COUNCIL ASSESSMENT REPORT

SYDNEY WESTERN CITY PLANNING PANEL

PANEL REFERENCE & DA NUMBER	PPSSWC-304 - DA-1262/2022
PROPOSAL	Concept Development Application for the construction of a 31-storey mixed-use development consisting of the establishment of the building envelope, gross floor area, maximum building height, design excellence, public domain works, vehicular access and car parking provision, stormwater management and concept landscape design.
ADDRESS	Lot 100 DP 1250893 402 Macquarie Street Liverpool 2170
APPLICANT	Kingdom Towers 1 Pty Ltd C/- The Planning Hub
OWNER	Kingdom Towers 1 Pty Ltd
DA LODGEMENT DATE	13/01/2023
APPLICATION TYPE	Concept DA
REGIONALLY SIGNIFICANT CRITERIA	Clause 2, Schedule 6 of <i>State Environmental Planning Policy (Planning Systems) 2021</i> : CIV over \$30 million
CIV	\$133,600,000.00 (excluding GST)
CLAUSE 4.6 REQUESTS	Clause 7.4 Building Separation pursuant to the <i>Liverpool Local Environmental Plan 2008</i>
KEY SEPP/LEP	<i>State Environmental Planning Policy (Planning Systems) 2021; and</i> <i>State Environmental Planning Policy (Transport and Infrastructure) 2021; and</i> <i>State Environmental Planning Policy (Biodiversity and Conservation) 20

Figure 1: Western elevation of adjoining mixed-use building at 166-176 Terminus Street, Liverpool approved under DA48/2015. Level 7 & 8 achieve a 6.1m setback to sites south-western boundary.

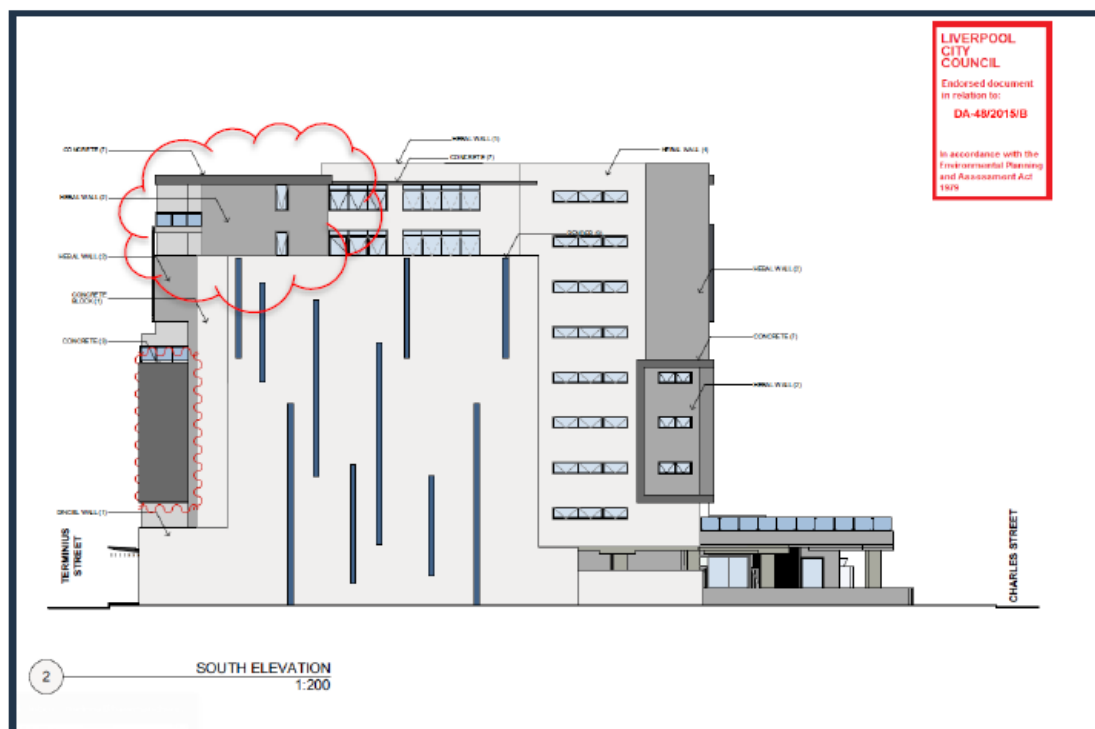
The below figures clearly show the top level of the eastern adjoining mixed-use development recessed from its south-western side boundary of 6.1m and the non-compliance on relate to a small section of the adjoining building on levels 7 and 8.
